ARBORICULTURAL IMPACT ASSESSMENT

**Concrete Access Cul-de-Sac
North of**

**The Hexagon,
Fitzroy Park,
London,
N6 6HR.**

Planning Reference: 2016/3252/P

ISSUE: -
 CLIENT: Bernard Carnell
 LOCATION: 4 The Hexagon, Fitzroy Park, London, N6 6HR
 DRAWING TITLE: Tree Constraints Plan (TCP)

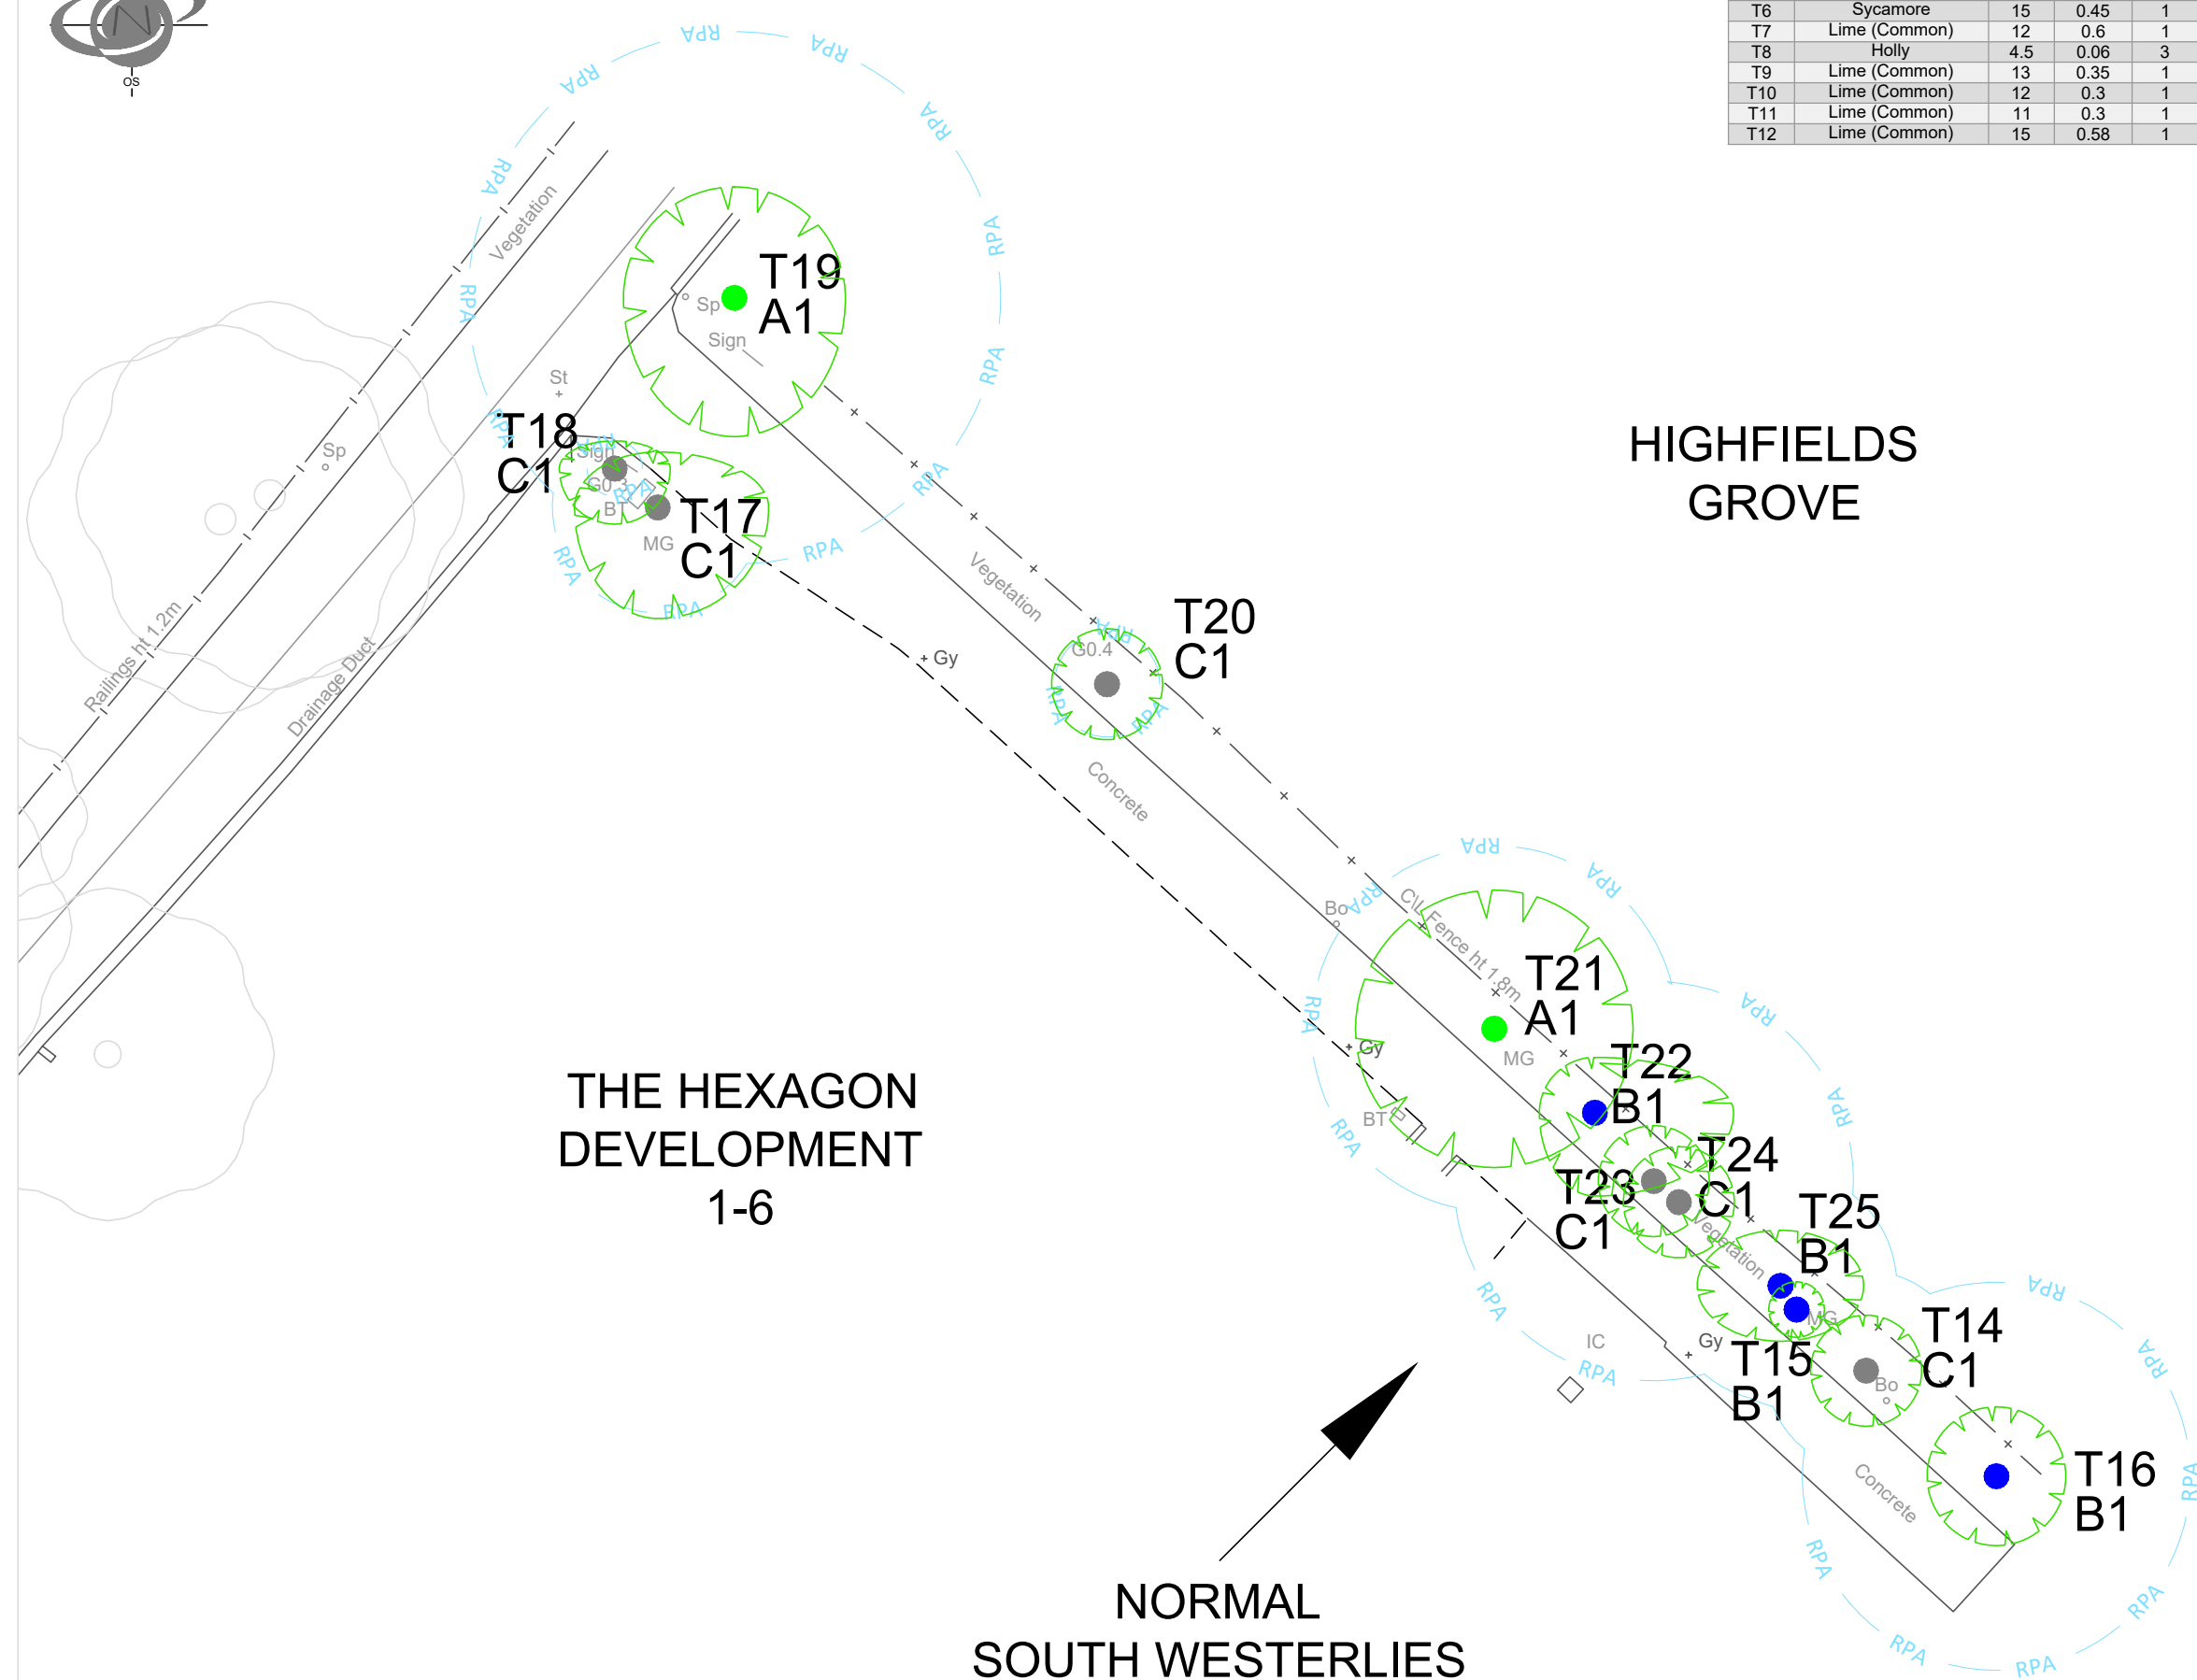
7.2.1 The development will require the installation of a new surface entirely within the RPA of all of the twelve trees surveyed: the LPL survey numbering commences adjacent No. 2 the Hexagon, with two trees in the ownership of No. 2 (T17 and T18).

7.2.2 All of the remaining ten trees are found on Highfields Grove verge land immediately to the north of the concrete cul-de-sac.

7.2.5 The disruption to these trees, which under all circumstances must be retained, cannot be minimised. Any installation of a 'reduced / no-dig' surface in the area on the concrete access strip would mean that these surfaces sit above ground level only *after* the concrete has been broken up and surface vegetation removal has been undertaken. It would not be possible to ensure that no tree roots are severed during the installation.

7.2.6 See the WSP Report, which identifies what degree and extent of re-engineered surface is suggested. A 300-400mm depth would damage, if not sever, key roots of all trees on the northern side of the cul-de-sac.

7.2.7 This process will sever the roots on the windward side of all 10 trees (T19 to T25 and T14 to T16).
